Addendum 50 – UN Regulation No. 51

Revision 3 - Amendment 7

Supplement 7 to the 03 series of amendments – Date of entry into force: 4 January 2023

Uniform provisions concerning the approval of motor vehicles having at least four wheels with regard to their sound emissions

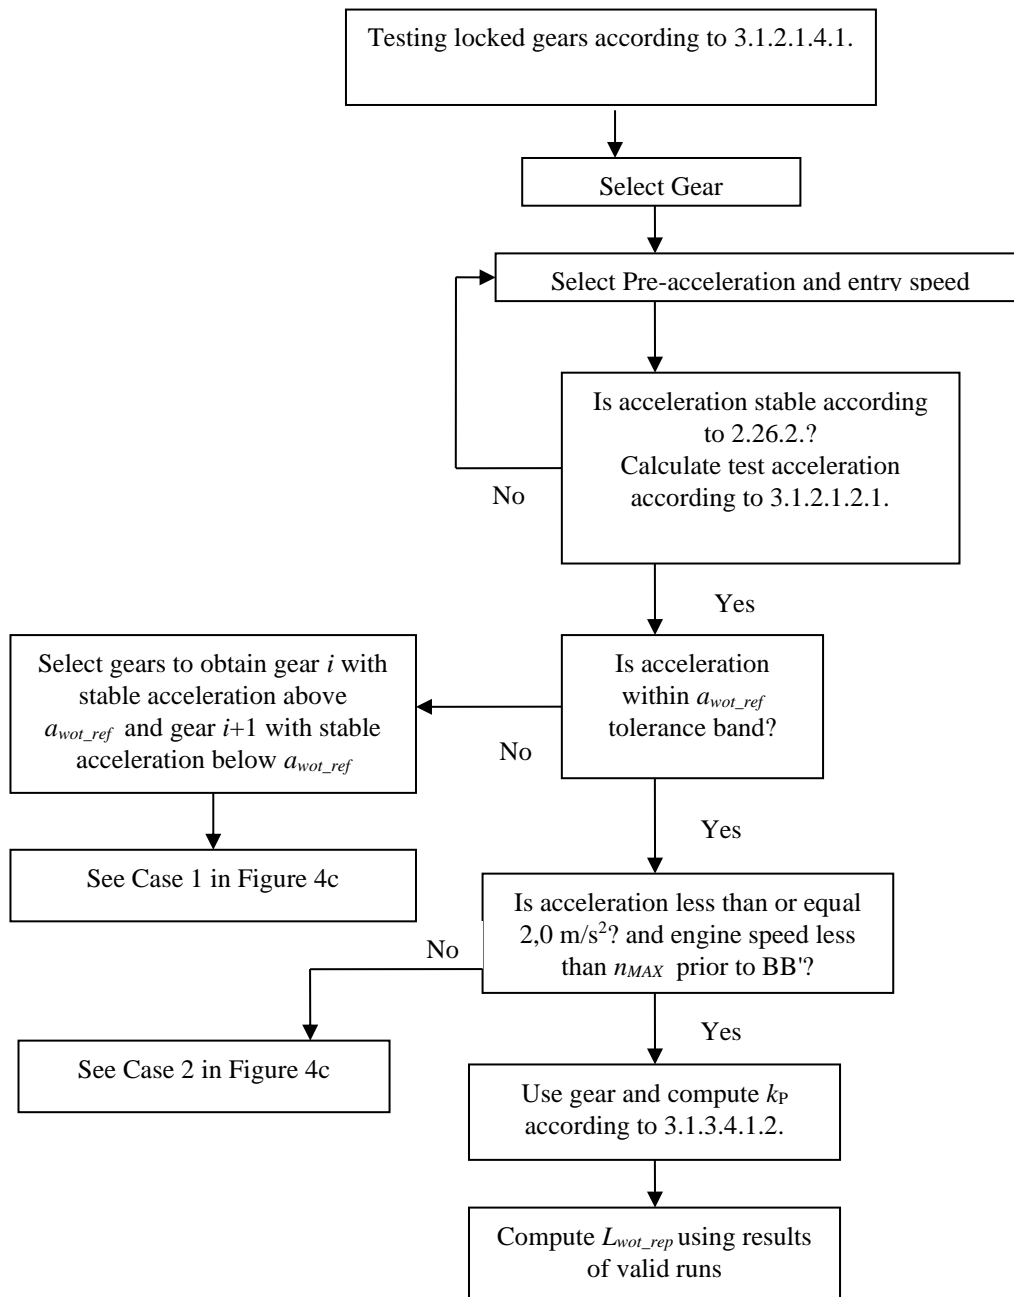
Paragraph 3.2.3., amend to read:

"Figure 4c
**Flowchart for vehicles tested according to paragraph 3.1.2.1. of Annex 3 to this Regulation –
 Gear selection using locked gear PART 2**

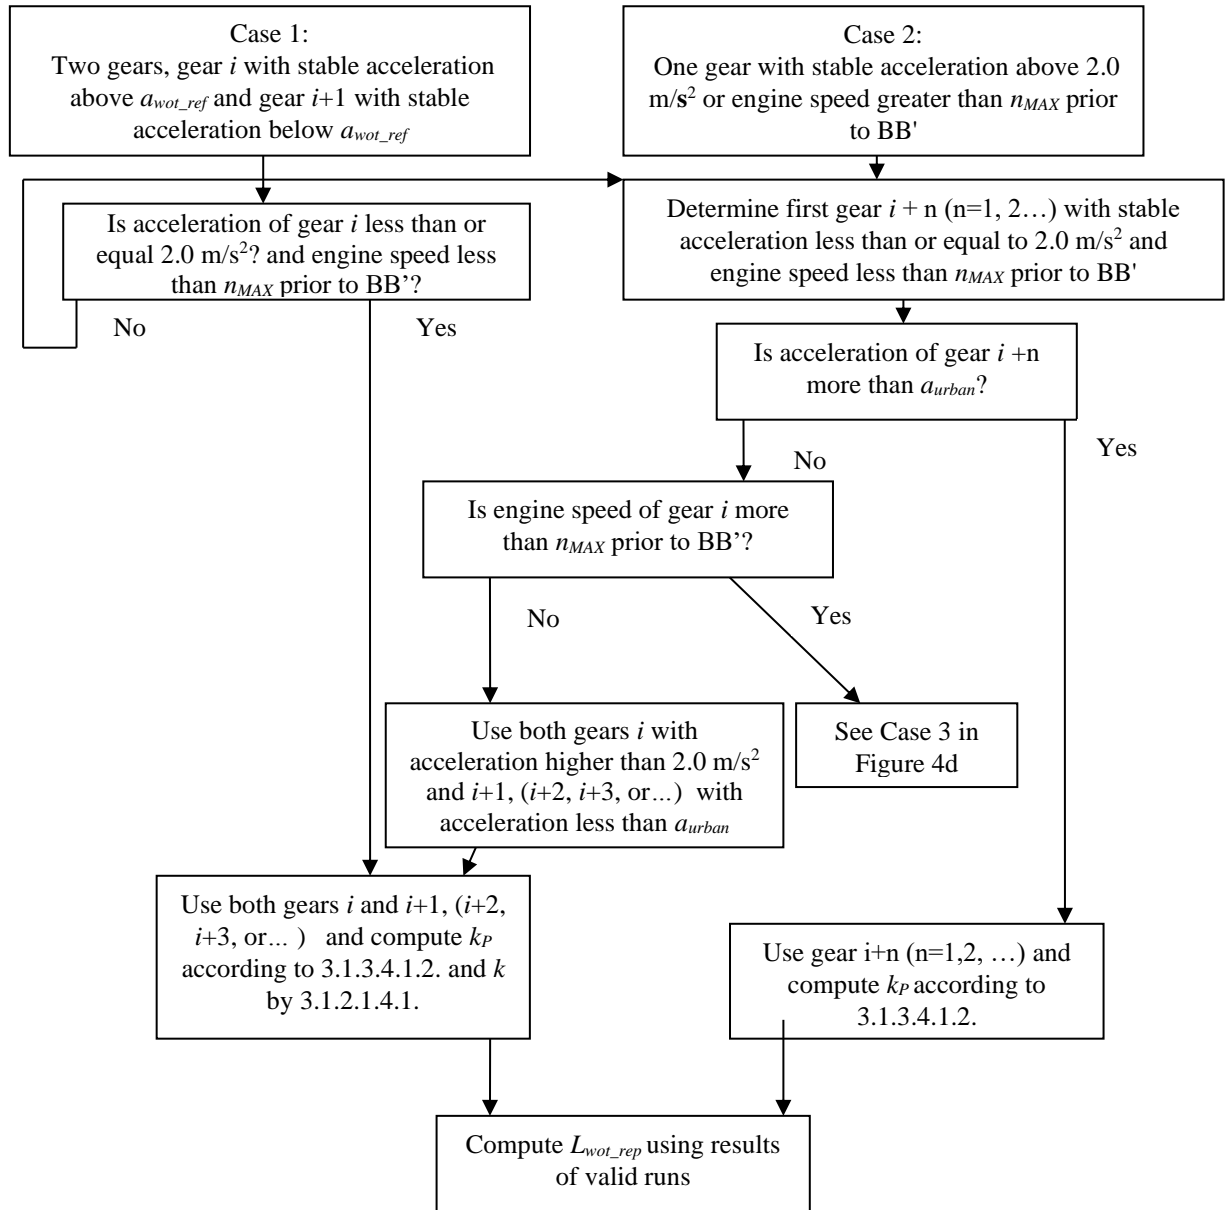
Annex 3 – Appendix 1 (renumbered), Figure 4c, amend to read:

**Flowchart for vehicles tested according to paragraph 3.1.2.1. of Annex 3 to this Regulation –
Gear selection using locked gear PART 3**

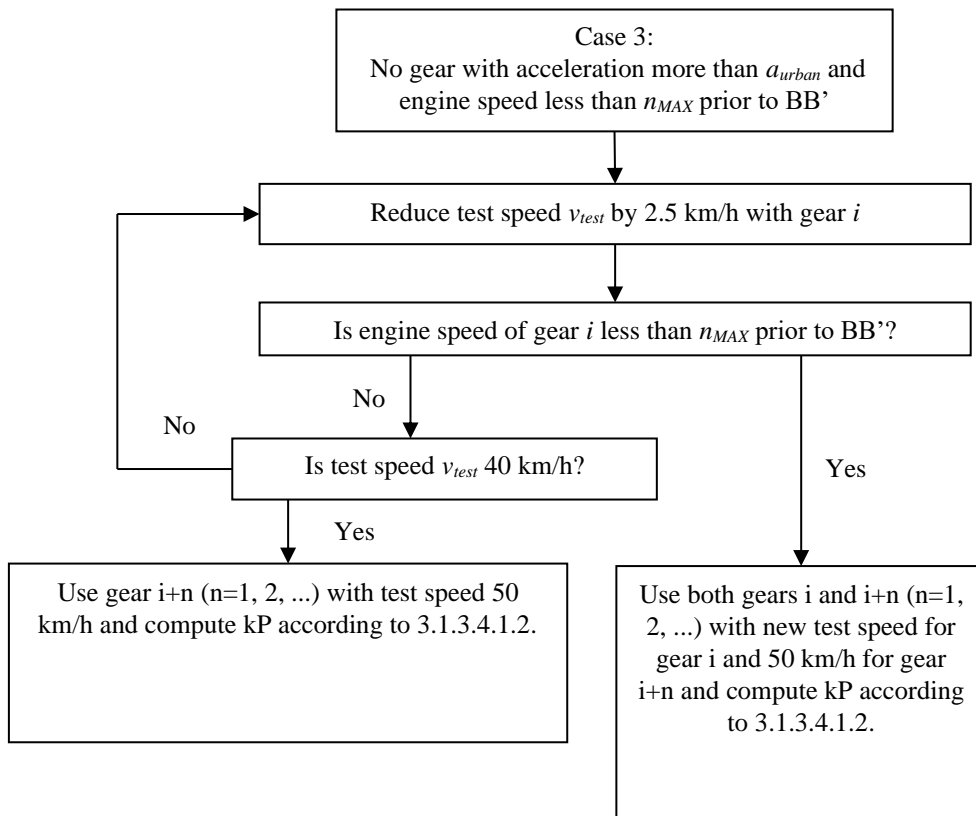
Annex 3 – Appendix 1 (renumbered), Figure 4d, amend to read:

"Figure 4e
**Flowchart for vehicles tested according to paragraph 3.1.2.1. of Annex 3 to this Regulation –
 Gear Selection using non-locked gears**

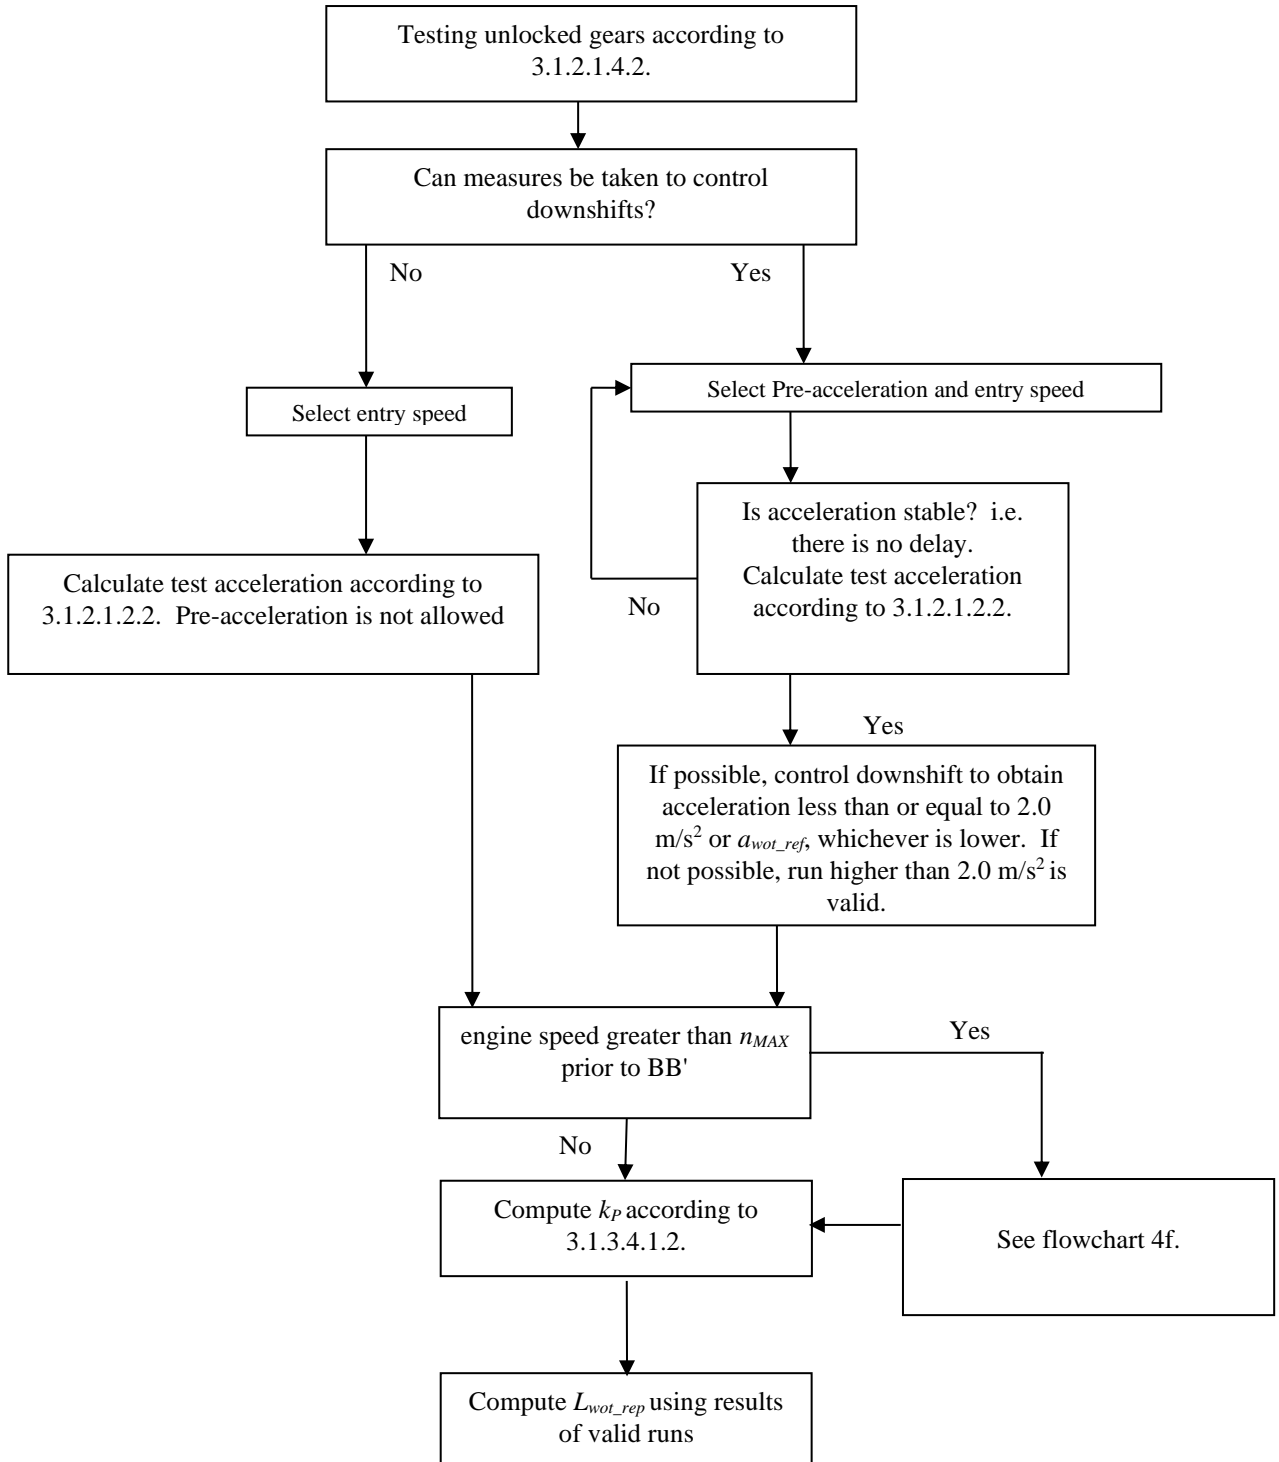
Annex 3 – Appendix 1 (renumbered), Figure 4e, amend to read:

Flowchart for vehicles tested according to paragraph 3.1.2.1.4.2. of Annex 3 to this Regulation – Gear Selection using non-locked gears

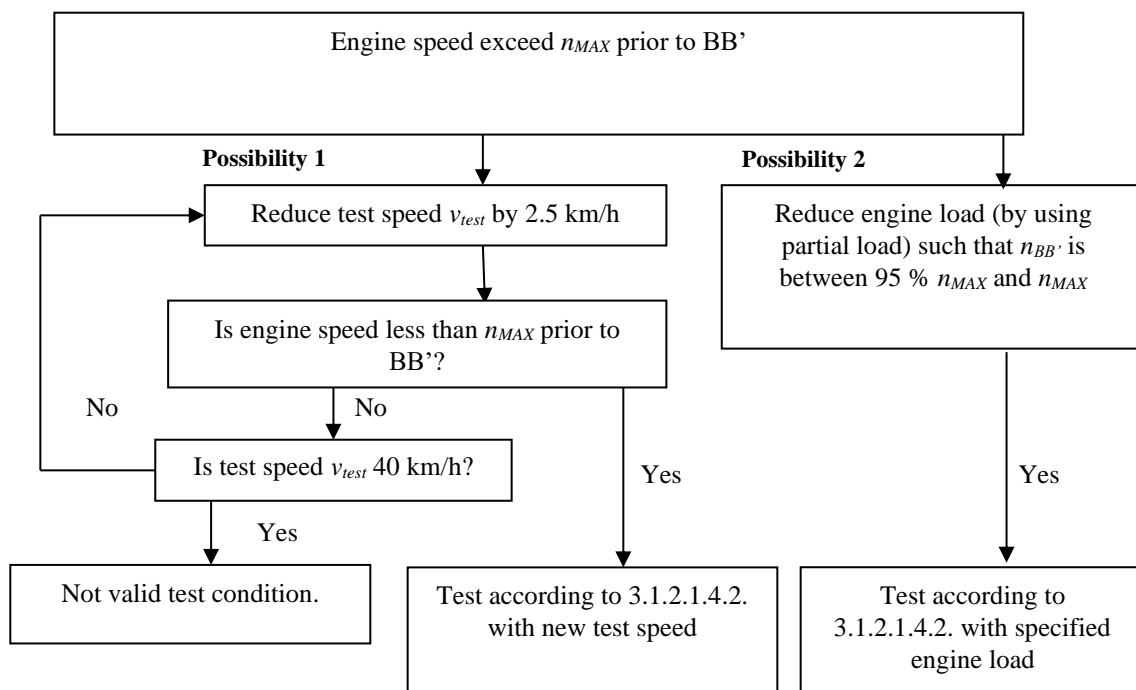
Annex 3 – Appendix 1 (renumbered), add a new Figure 4f, to read:

Figure 7a
Flowchart for vehicles tested according to paragraph 3.1.2.1. of Annex 3 to this Regulation – Correction of pass-by measurements for temperature and if applicable for test track differences

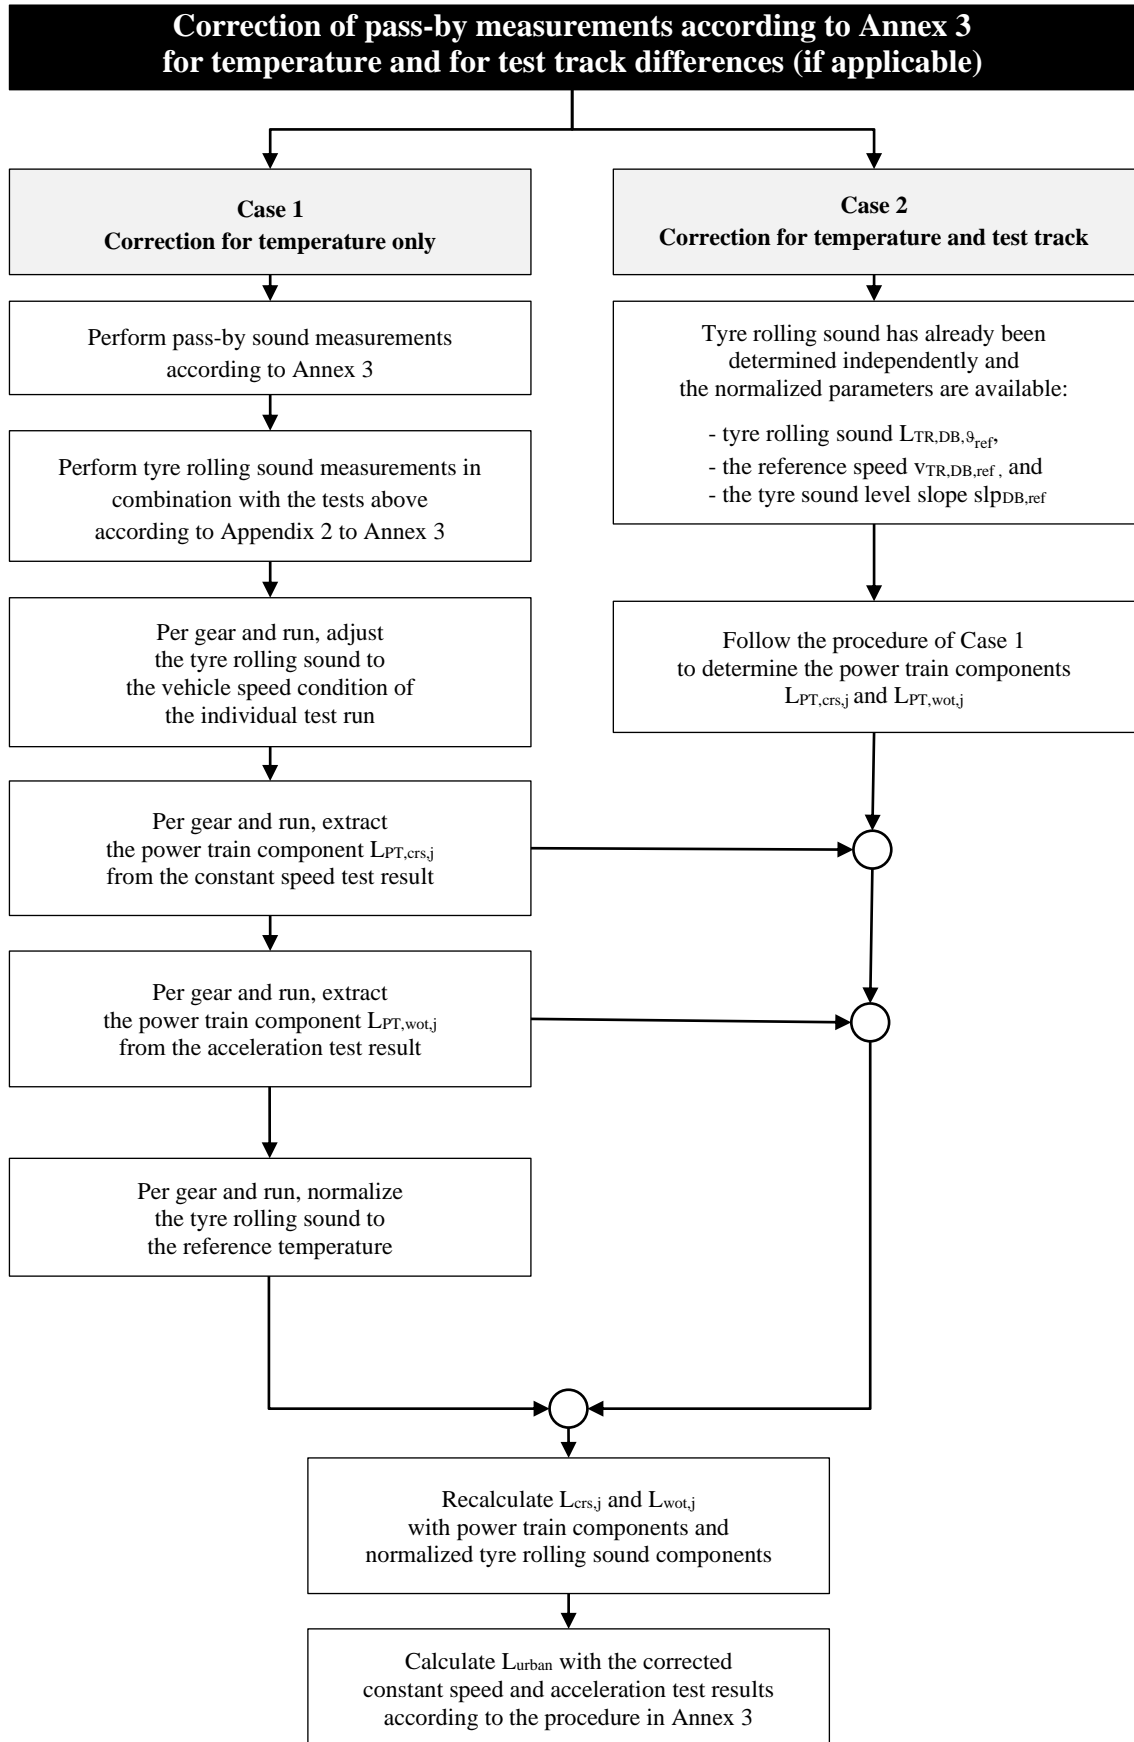
Annex 3, add a new Appendix 2 to read:
